Access Compliance Report

Public Rights-of-Way (Curb Ramps)

Main Street: MADISON_AVE		Cross Street: NEWLAND_ST		Location:	NW
ADA ID: RPRK220203130749	Ramp Type: Type 4 - Parallel	Initial Pass/Fail: Fail	Overall Compliance: No	Severity Score:	15

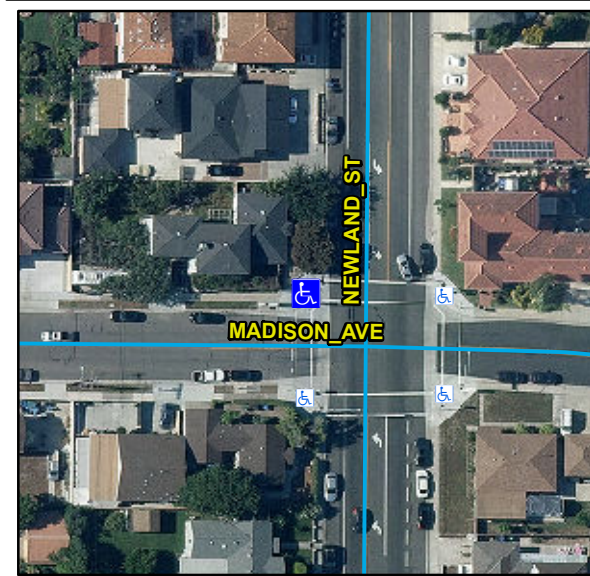
Compliance	Description	Data	Compliance	Description	Data
N/A	Ramp Length LT (in)	96	N/A	Ramp Length RT (in)	99
Yes	Ramp Width LT (in)	152	Yes	Ramp Width RT (in)	152
Yes	Ramp Run Slope LT (%)	7.8	Yes	Ramp Run Slope RT (%)	4.8
No	Ramp Cross Slope LT (%)	4.3	No	Ramp Cross Slope RT (%)	5.1
N/A	Landing Present	N/A	N/A	DWS Provided	N/A
N/A	Landing Length (in)	N/A	N/A	DWS Contrast	N/A
N/A	Landing Width (in)	N/A	N/A	DWS Length (in)	N/A
N/A	Landing Run Slope (%)	N/A	N/A	DWS Full Width	N/A
N/A	Landing Cross Slope (%)	N/A		DWS Offset Type	N/A
N/A	Landing Movement Obstructed?	N/A	N/A	DWS Offset Left (in)	N/A
	Landing Movement Type	N/A	N/A	DWS Offset Right (in)	N/A
N/A	Landing Shared	N/A			
N/A	Clear Space	Yes			
N/A	Clear Space To Crosswalk (in)	48			
N/A	Marked Crosswalk 1	Yes	N/A	Marked Crosswalk 2	Yes
	Crossing 1 Direction	S		Crossing 2 Direction	E
	Marked Crosswalk 1 Width (in)	144		Marked Crosswalk 2 Width (in)	144

Remove & Replace Curb Ramp With Two New Directional Ramps or Equivalent.
